# Technical Bulletin

**No:** ITCM-0017-B  
Page 1 of 1

**Models** Amana RC Chassis and Menumaster MRC Chassis Commercial Microwave Ovens

**Issue** Seal holes in Cavity Bottom when replacing Lower Antenna Motor or Oven Tray

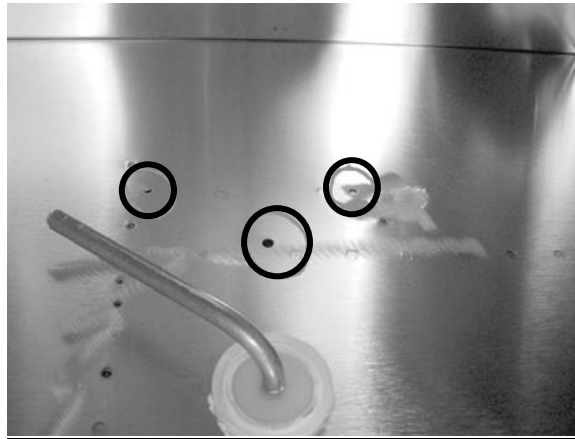
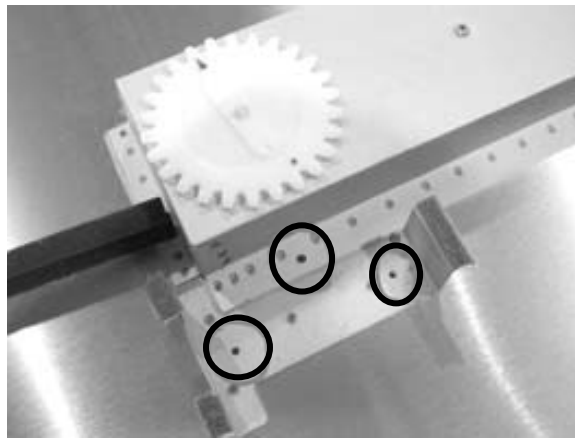
Analysis of failed lower antenna motors has indicated some failures may be caused by grease dripping through these holes and on to the motor.

**Action** If replacing the Lower Antenna Motor or Oven Tray on these models, seal the three holes shown below with RTV sealant at the same time.
